Historic District Commission Meeting

Informal Staff Review of Study Item at 300 W Michigan

300 W Michigan (former EMU College of Business)

2. From the corner of Michigan Ave and Adams:

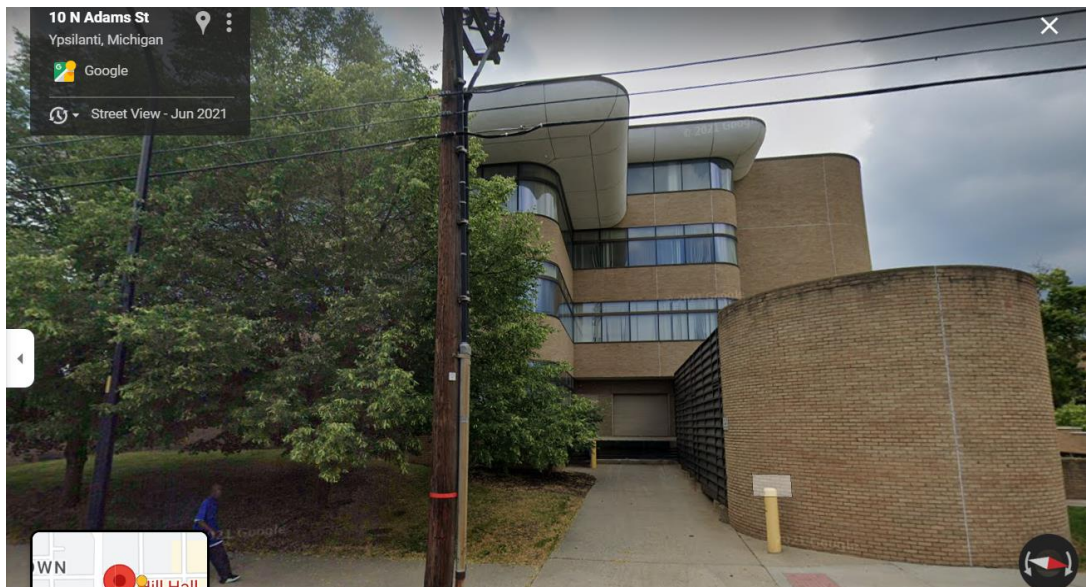
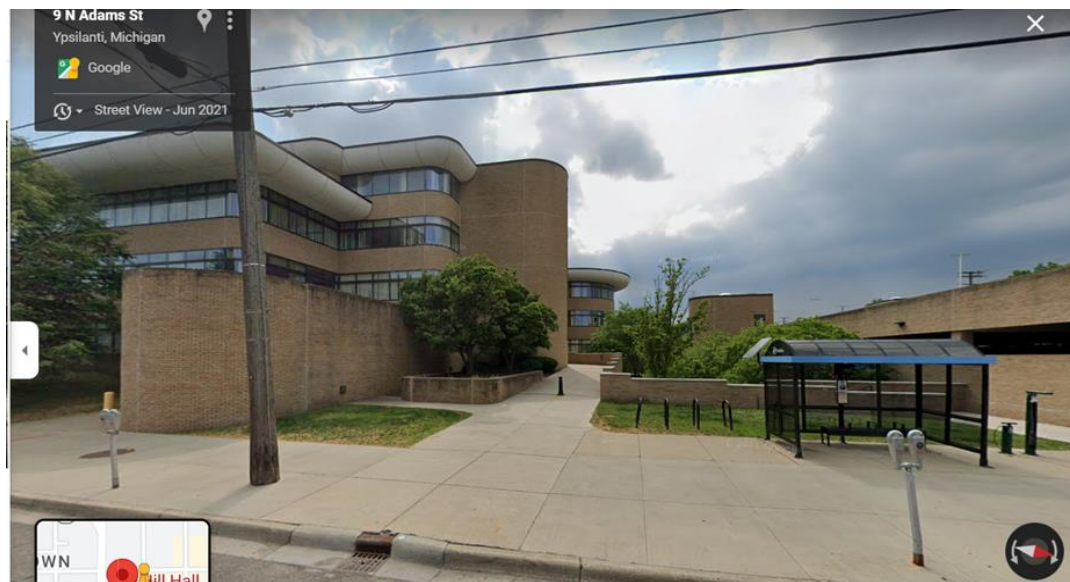
Staff is researching if there is a chance that this building could be considered significant even before it is 50 years old. Assuming that it is not, staff wonders if there is a way to see whole elevations stained gray. Sometimes, dark colors on a building give it more visual weight, making the building (and parking

structure) appear larger. In this case, if the buildings look even larger than they are, that could negatively impact the nearby, smaller historic resources.

Staff wonders if the windows across all the facades are being replaced? The windows across the facades in the rendering look more mirrored than they do on the Google streetviews, but perhaps that's just the way the rendering looks on the screen. If the windows will be replaced, clear glass is usually recommended in the historic district.

It seems to staff that how we treat our aging buildings is important in terms of future preservation efforts. So, thinking about the original design team's intent, it seems to staff that the overhang is a distinctive element that should be retained.

PROJECT	MI-HQ - YPSILANTI	DATE	JUN 2 2022
SITE PLAN EXHIBIT		COMUS CONSULTING 106 S. MAIN STREET ANN ARBOR, MICHIGAN 48104

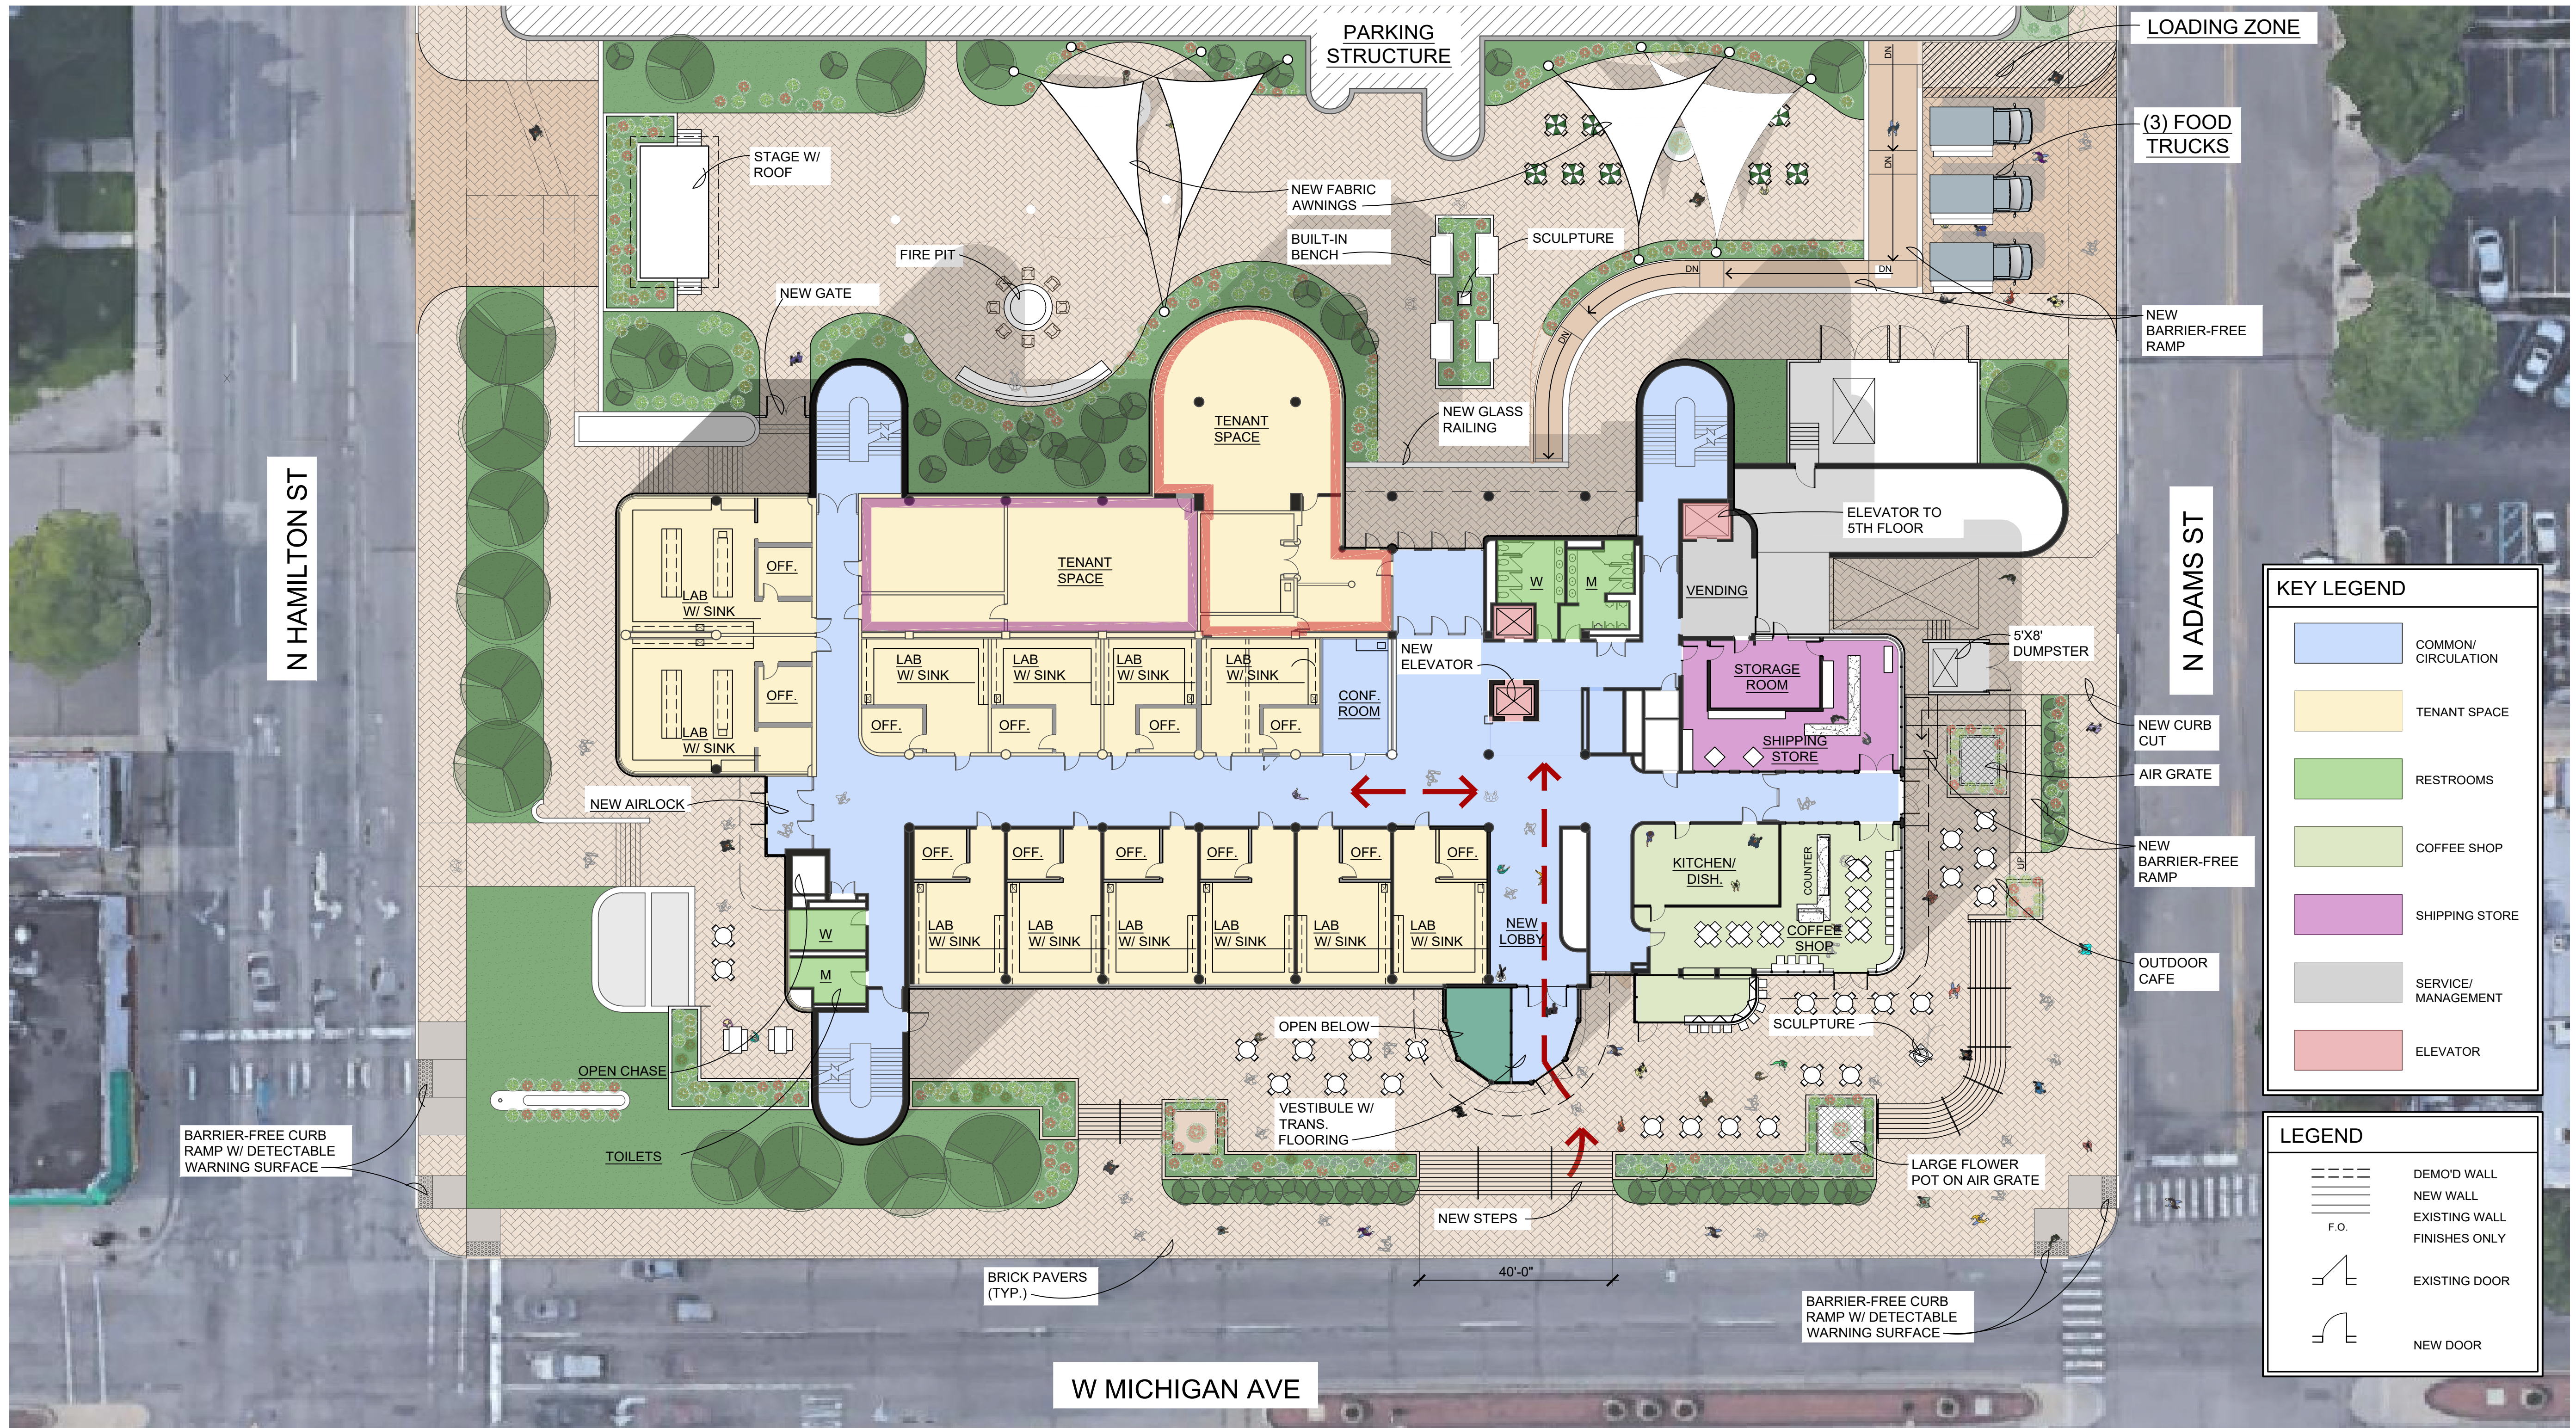
We plan to remove the existing brick walls to make a more welcoming entry plaza.

We will landscape the beds with lower plants to eliminate barriers between the pedestrians and the building. We want this to be a welcoming space that pulls people in.

We are hopeful to replace much of the **sidewalk** in front, east and west end of the building with brick pavers. Lower retaining walls with builtin **planters** will replace the current brick walls that block visitors."
